April 16, 2010  
NRC3-10-0016

Subject: Detroit Edison Company Response to NRC Request for Additional Information Letter No. 25

**Response to RAI Letter No. 25  
(eRAI Tracking No. 4339)**

Figure 13.1-201 Design and Construction Organization

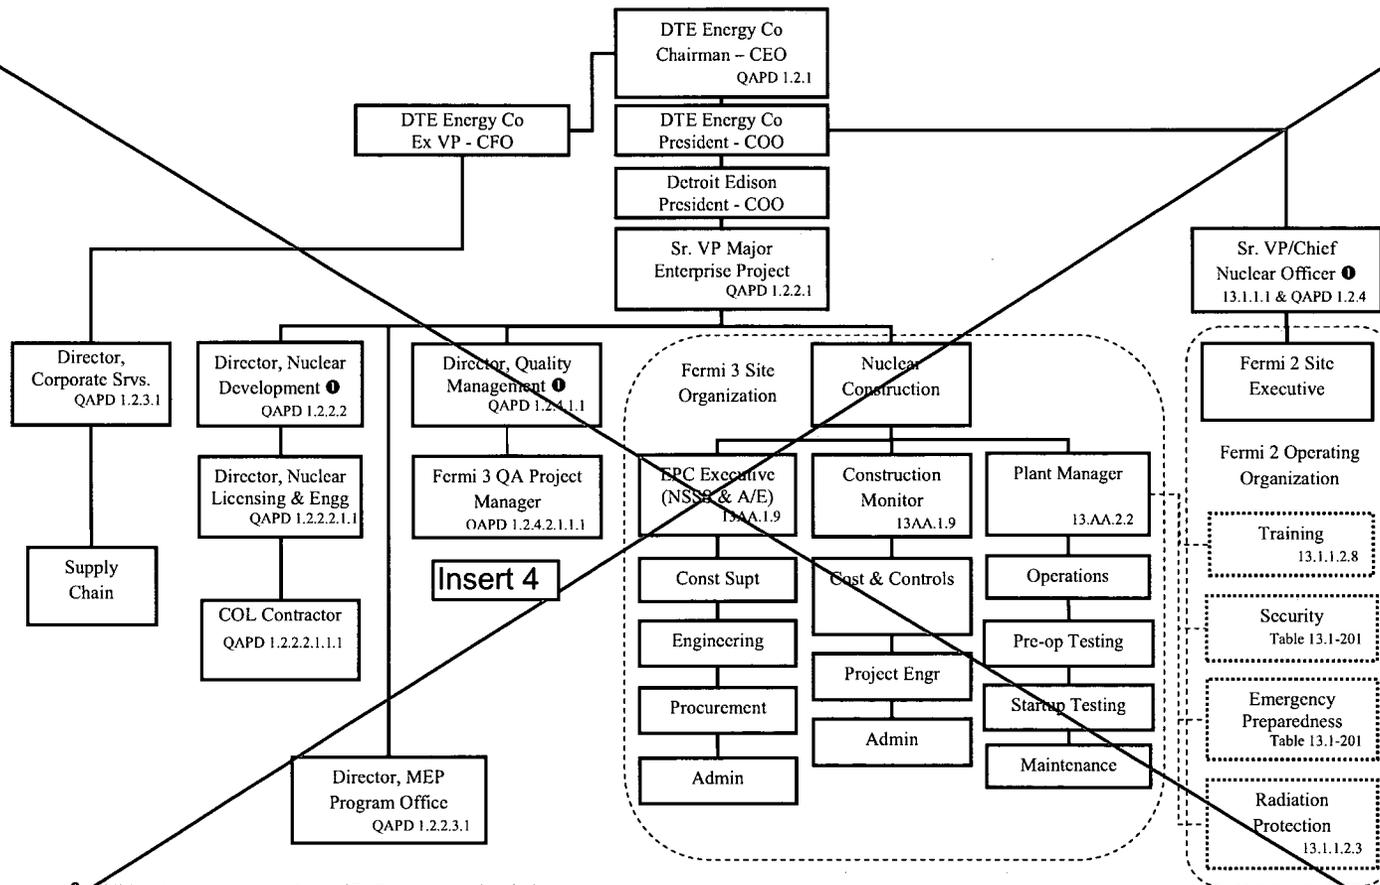
The organizational description presented in Appendix 17AA includes the onsite and offsite organizational elements that function under the cognizance of the Fermi 3 QA program. FSAR Figure 13.1-201 and QAPD Figures II.1-2 and II.1-3 have been revised to identify those organizational elements that are on the Fermi site.

FSAR Figure 13.1-201 is being revised as shown in the attached markup. FSAR Figure 13.201 is also included in the markup provided with the response to RAI 17.5-10 in Attachment 8.

**Figure 13.1-204**  
**Fermi 3 Site Organization**  
**(Operations)**

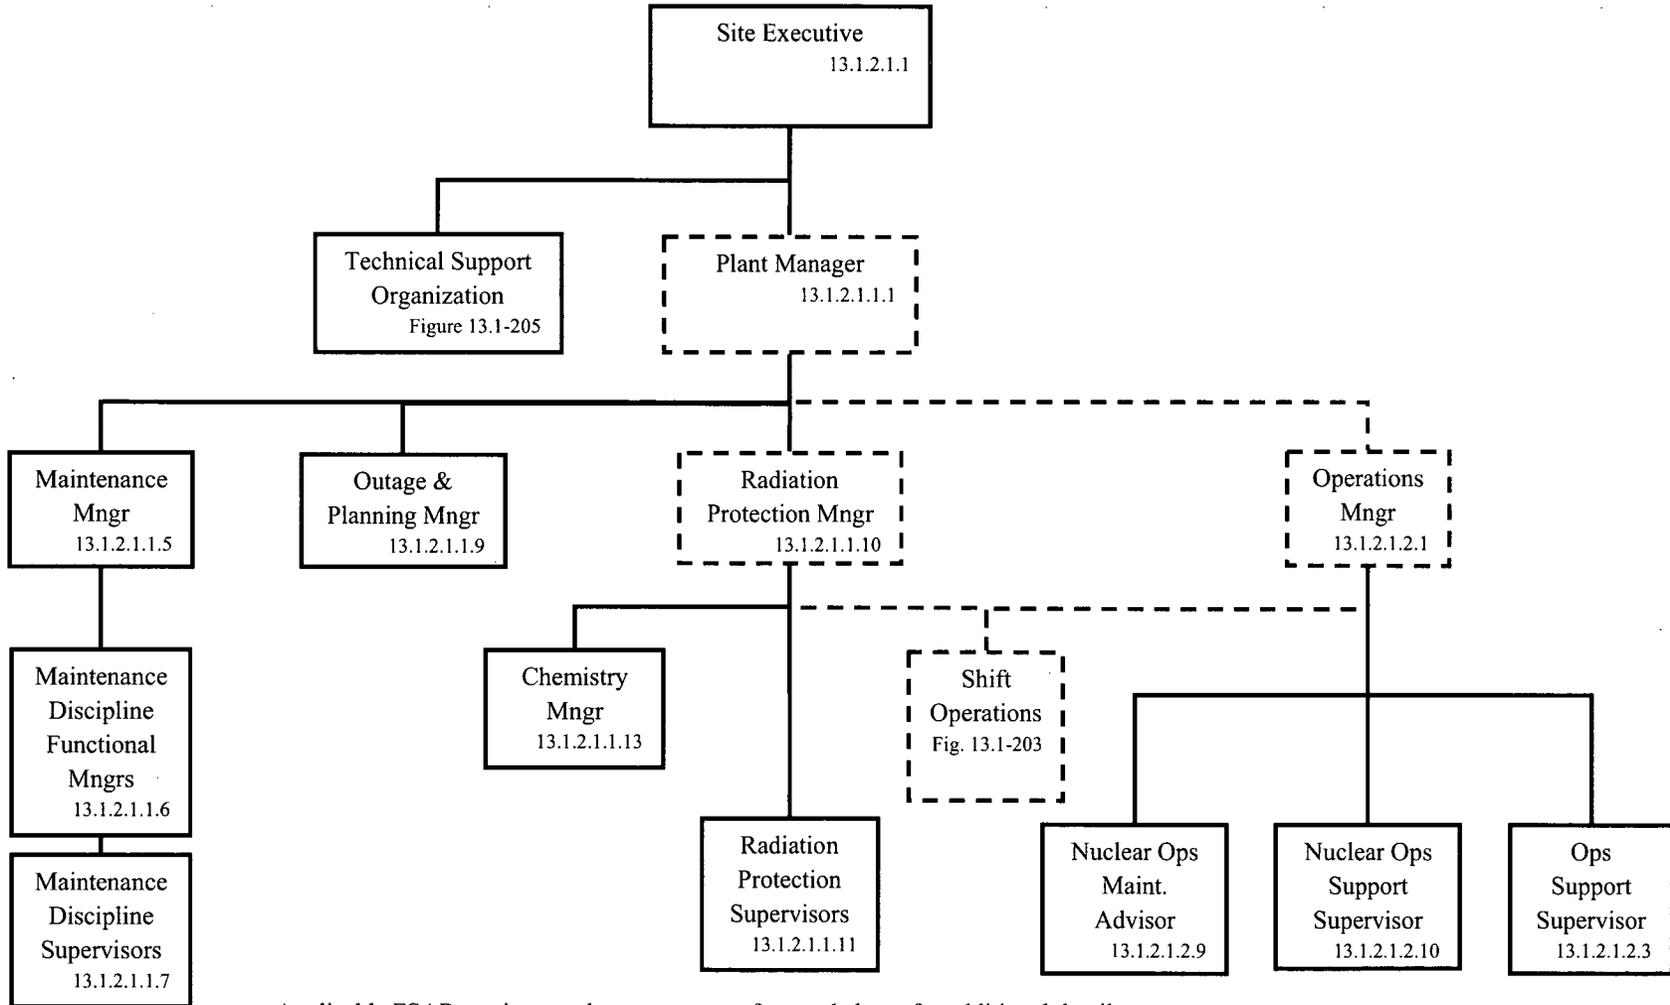
The organization charts presented in Appendix 17AA, "Fermi 3 Quality Assurance Program Description," Figures II.1-1, II.1-2, and II.1-3 and FSAR Figures 13.1-201, 204, 205 and 14AA-201 have been revised to reflect those positions associated with the establishment, implementation, and verification of quality related activities. QAPD Figure II.1-3 (corporate management), FSAR Figure 13.1-204 (operating organization) and FSAR Figure 13.1-205 (technical support organization) detail the responsibilities and lines of authority for the positions necessary to implement the requirements for an operational 10 CFR 50, Appendix B program. The reporting lines for the independent review functions are identified. Comparable detail for the construction organization is provided through the addition of the EPC organization, including the reactor technology vendor with its NRC approved QAPD and the Architect/Engineer with its Detroit Edison approved QAPD, and the Startup Test Group which would function under the plant manager.

**Figure II.1-1  
Fermi 3 Pre-COL Organizational  
Structure**

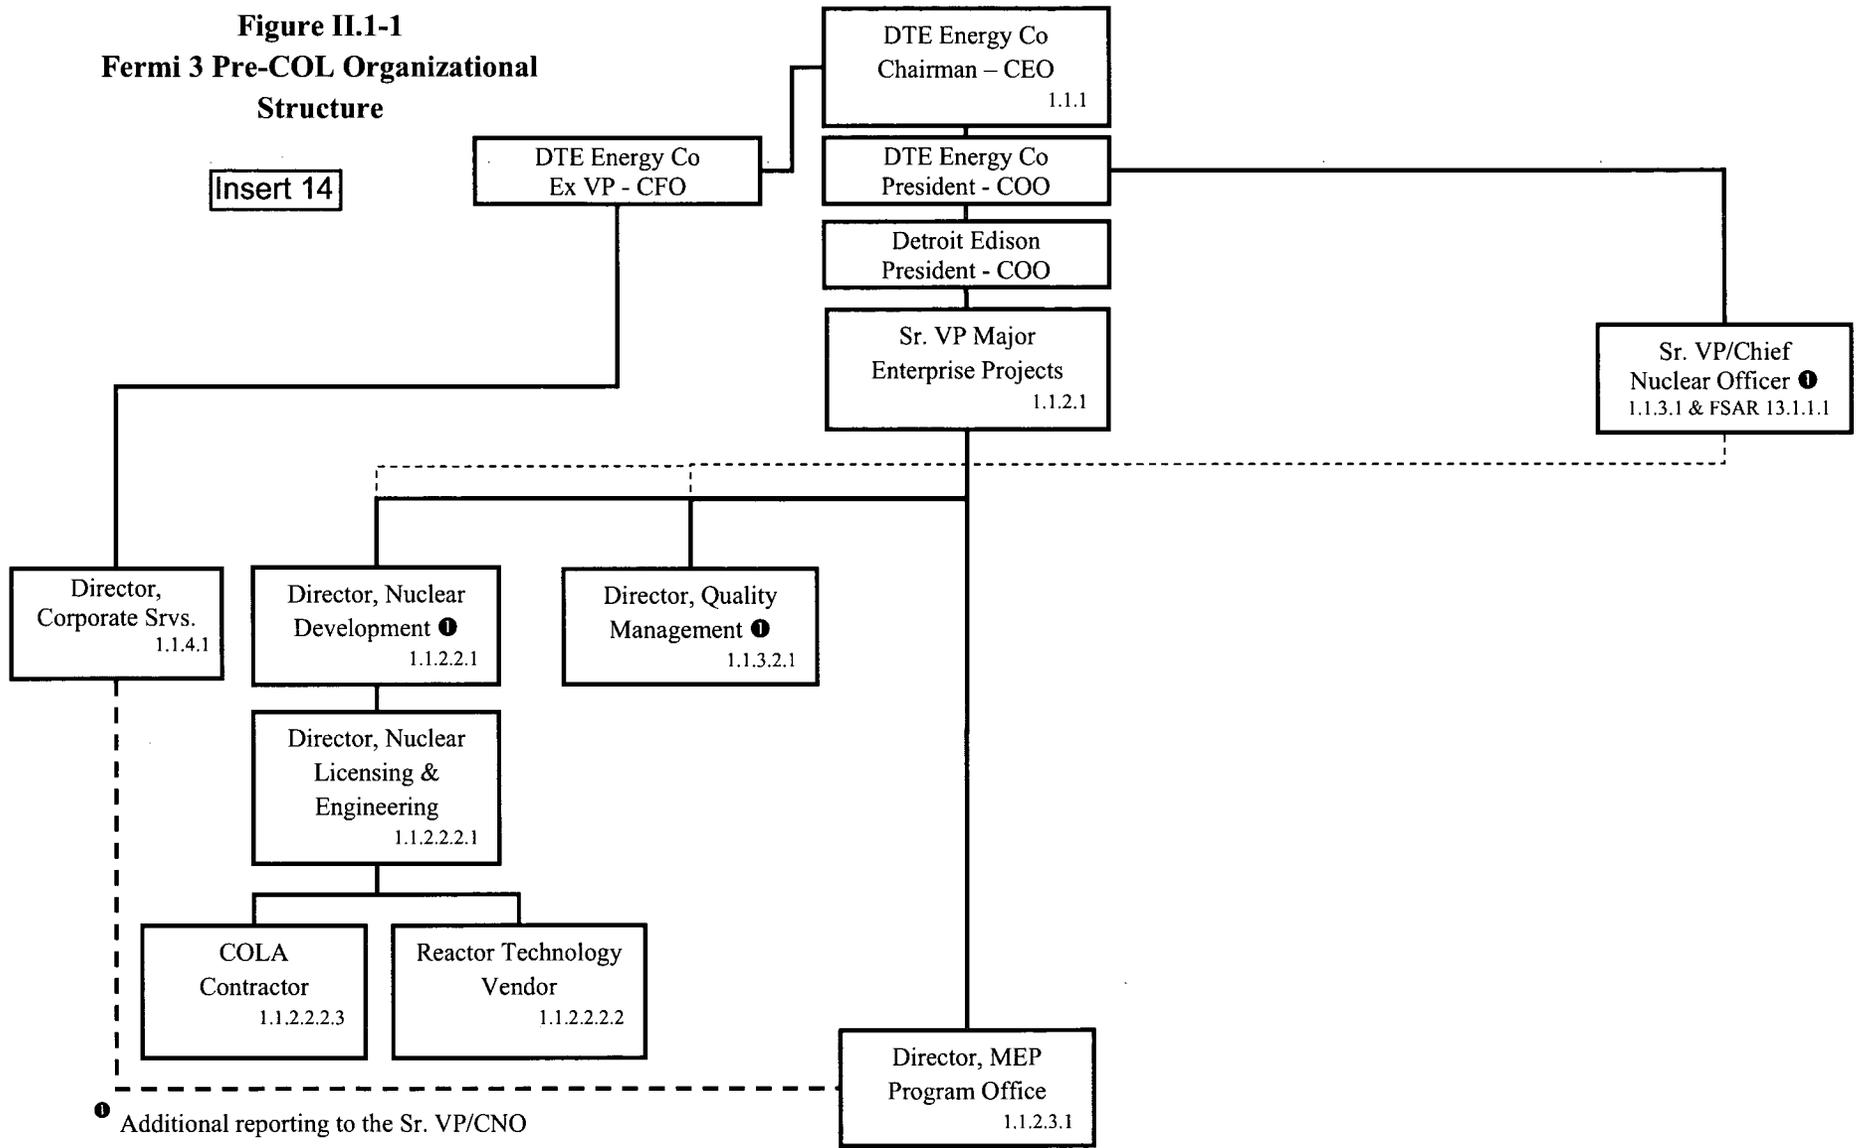
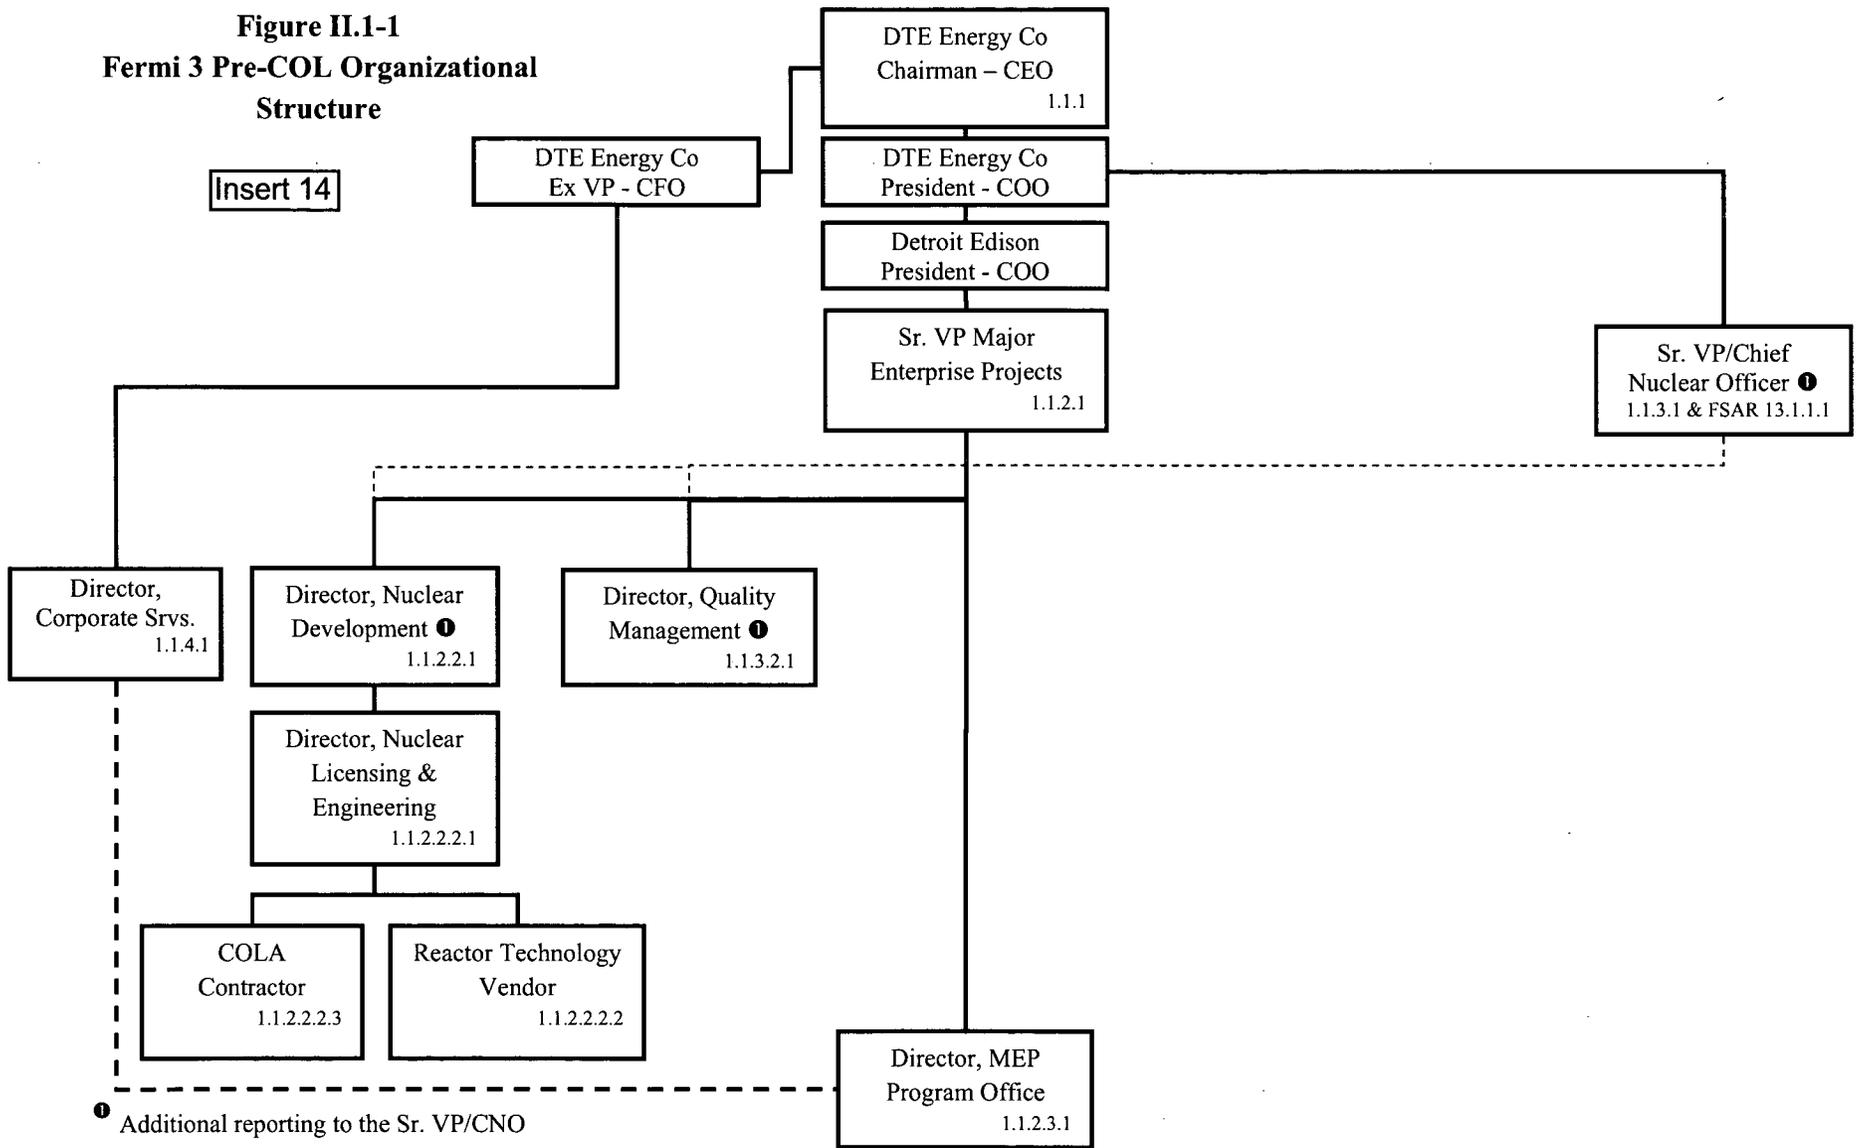
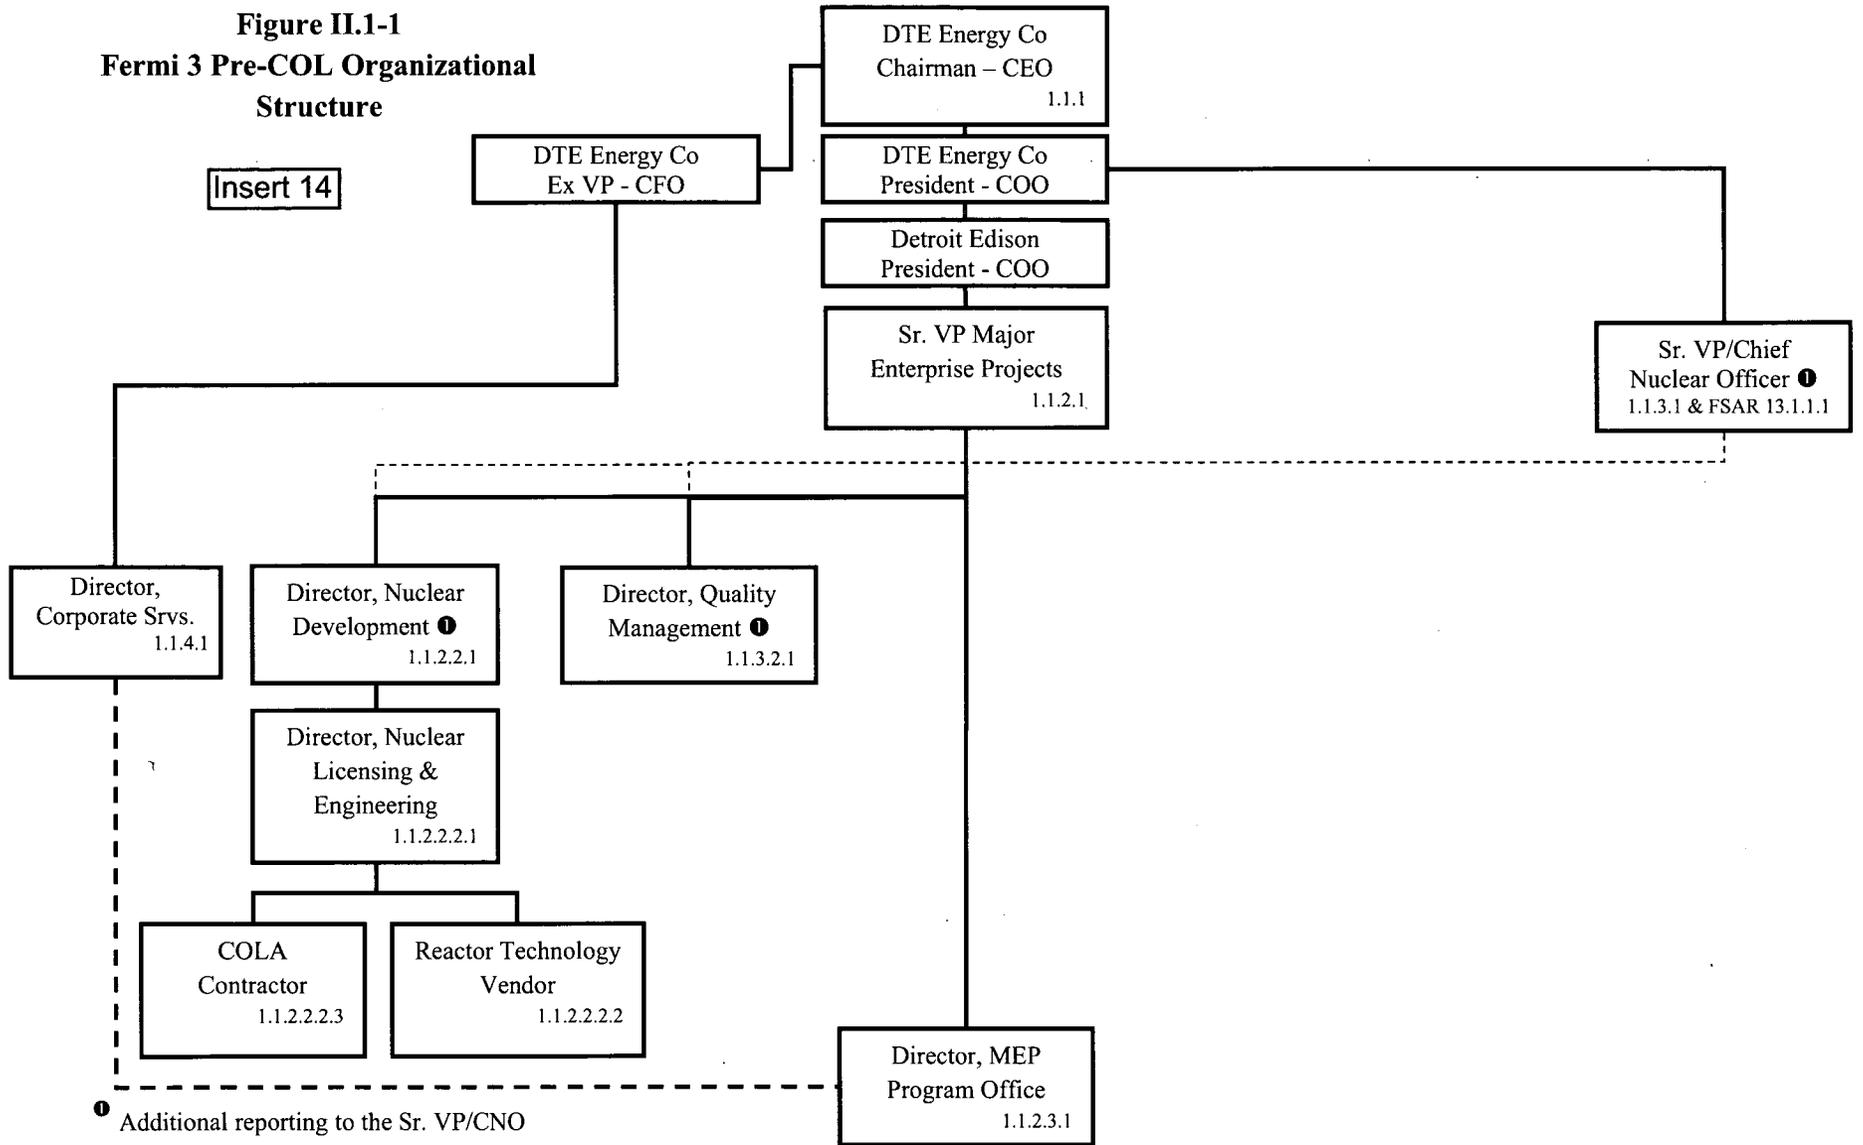
The interfaces for each of the primary contractors, the reactor technology vendor, the COLA contractor, and the Engineering, Procurement and Construction (EPC) contractor and their position in the appropriate organizational chart were provided in the revision to Appendix 17AA, Figure II.1-1, "Fermi 3 Pre-COL Organization", and Figure II.1-2, "Design and Construction Organization."

Appendix 17AA, Figure II.1-1, "Fermi 3 Pre-COL Organization", and Figure II.1-2, "Design and Construction Organization" have been revised to provide the interfaces for each of the primary contractors, the reactor technology vendor, the COLA contractor and the EPC contractor as shown in the attached markup. The markup to Appendix 17AA, "Fermi 3 Quality Assurance Program Description" provided with RAI 17.5-12 in Attachment 10 also reflects these changes.

This functional relationship is now shown on QAPD Figure II.1-1 and the similarly functional relationship between the Supply Chain and Corporate Services presented in FSAR Subsection 13.1.1.2.12 is also now shown.
